A303 Sparkford to Ilchester Dualling Scheme TR010036

8.8 Draft Statement of Common Ground with Defence Infrastructure Organisation

STATEMENT OF COMMON GROUND

Version	Date	Status of Version
Rev A	January 2019	Draft for Deadline 2

Pond 4

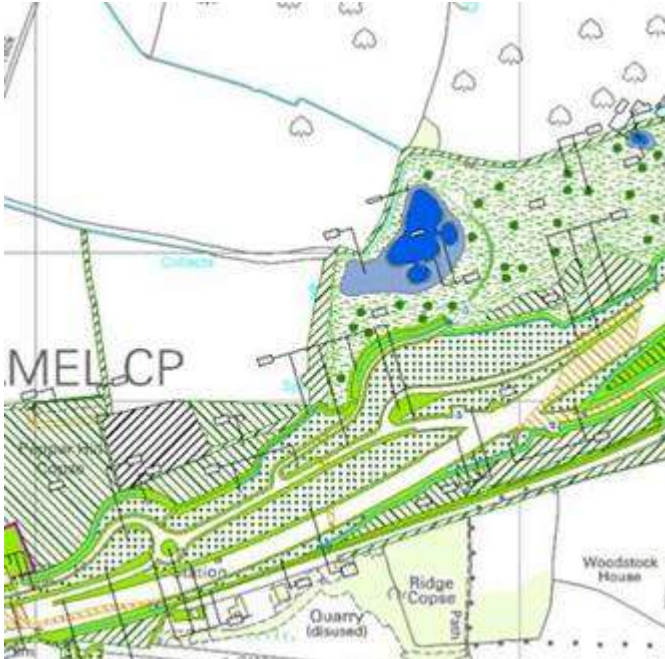
- 3.1.1 The Defence Infrastructure Organisation (DIO) is concerned that the proposal to construct six ponds which will contain permanent bodies of water could attract birds to the area and increase the risk of bird-strikes.
- 3.1.2 An assessment has been undertaken to assess the risk of bird-strikes, which is summarised below.

3.3.3 These ponds are generally sheltered and do not provide open views of the countryside except for the pond 4 that has open views to the south.

- There are limited records of problem bird species in the area;
- Ponds are generally sheltered apart from pond 4, which may require some additional measures.
- Adjacent road noise is likely to deter birds; and
- There will be no public access to these ponds to eliminate possible bird feeding.

- The planting adjacent to Pond 4 will be reviewed.
- Further discussion with the DIO's bird-strike safeguarding team would be useful.
